# Clause 104 Maintenance Requests #2

# Overview

Technical, 802.3bu, Page 53, Figure 104-8

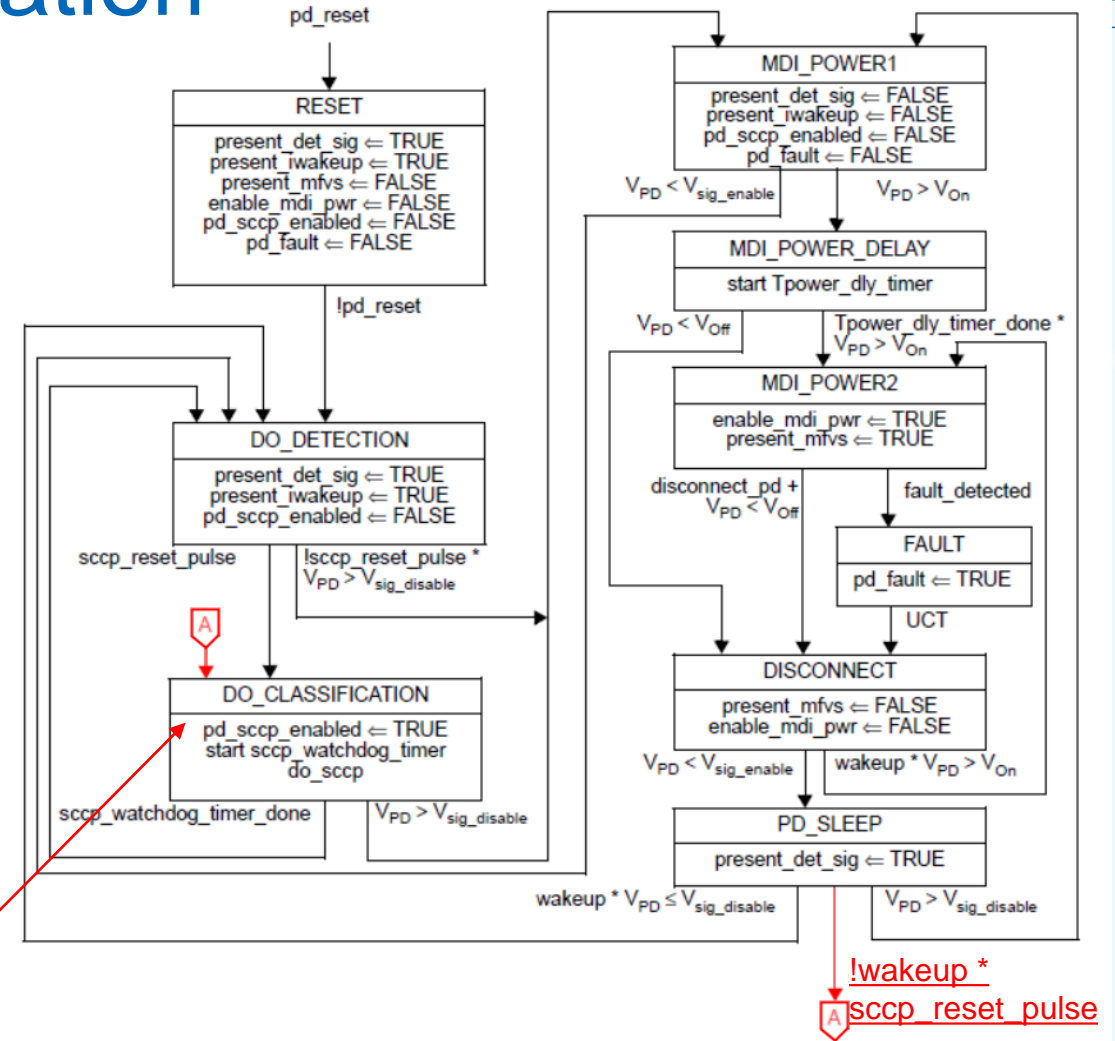
The PD state machine, as written, does not allow a PD to respond to SCCP classification on PD\_SLEEP exit.

Change wakeup

TRUE: the PD requires the full operating voltage at the PI.  
FALSE: the PD is ready to go to sleep.

To wakeup

An implementation specific variable enabling the PD to request wakeup.

TRUE: the PD requires the full operating voltage at the PI.  
FALSE: the PD is ready to go to sleep or is not otherwise requesting full operating voltage.

4/27/21 proposed add:  
present\_iwakeup <= FALSE
